County of Loudoun
Department of Planning
MEMORANDUM

SUBJECT: ZMAP 2008-0023, Cedar Green Church

Concept Plan Excerpt
(January 2, 2009)

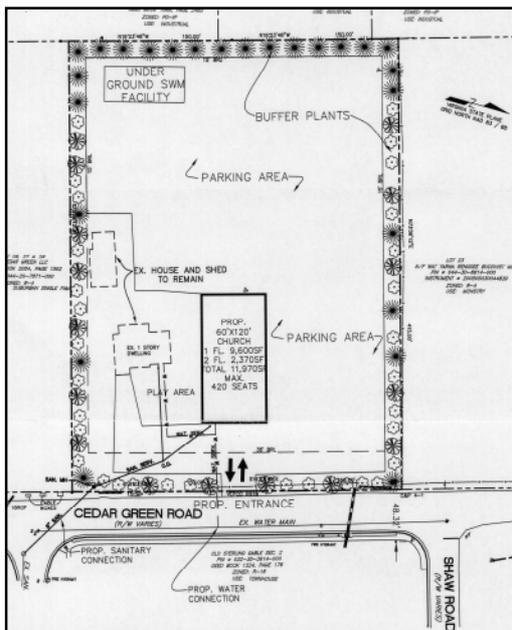
The proposed concept plan centers the church on the street frontage. The church is set back approximately 62 feet from the front property line. A vehicle entrance is placed directly in front of the church.

The concept plan depicts a building outline of 60 feet x 120 feet, but no details were provided regarding building design. With the exception of a planted buffer, the concept plan does not depict any defined open spaces.

While buffer plantings are depicted within setback areas, no landscaping is depicted within the parking areas or other internal portions of the site. A general depiction of trees, shrubs, grasses, perennials, depressed parking areas, and/or berms throughout the site would help determine whether the landscaping and buffering is adequate to ensure compatibility with the surrounding uses and to assess the visual impact of the project.

The proposed concept plan depicts the general location of parking to the side and rear of the church. No details have been provided regarding the extent of the parking or the number of spaces.

The applicant has designated an area in the southwest corner of the site as an underground stormwater management facility but has not provided any further details regarding water quality and quantity controls. Staff notes that a curb and gutter system has been installed on the east side of Cedar Green Road.

Staff recommends that the applicant provide further details regarding vehicle circulation with clearly defined entrance lanes, curbs, sidewalks, and drop-off points, as applicable, so that the streetscape can be evaluated. The applicant should consider relocating the entrance driveway further to the north, to enhance the views of the church from the street and the surrounding community. Street trees should be placed to create an overhead leaf canopy for Cedar Green Road. The applicant should also consider gateways, walls, enhanced plantings, or other design elements along the Cedar Green Road frontage.

Staff recommends the application be revised to include details regarding building placement and design so that the application can be evaluated against County policies. The following building placement and design issues should be considered to ensure compatibility with the surrounding community:

Given the proximity of residential uses, additional details are needed to determine whether the proposed use is compatible with the surrounding residences. Staff recommends that the applicant commit to a landscape plan with special attention to the project's visual impact. Elevations and plantings should be planned so that parking is screened and views of the use are filtered from the residences. Staff also recommends that the depicted plantings be augmented around the building with special consideration to the building frontage along the entrance driveway to frame the church. The applicant should commit to the landscaping and buffering, a long-term maintenance plan, and the use of native species for most or all of the plantings.

Staff recommends that the concept plan provide information regarding the location of parking, travel lanes, drop-off points, and the number of parking spaces. All parking should be placed behind buildings, where appropriate.

Staff recommends that the applicant consider employing LID facilities on-site. Staff recommends water treatment measures that mimic the pre-development conditions of the site, mitigate impacts to the watershed, and treat the stormwater runoff as an amenity. The applicant should consider various site measures, such as permeable pavers, porous concrete, cisterns, planted swales, curb cuts, rain gardens, and bioretention filters adjacent to impervious areas, to promote infiltration on-site, minimize peak storm flows, and help filter non-point source pollutants. Pipe installation should be minimized.
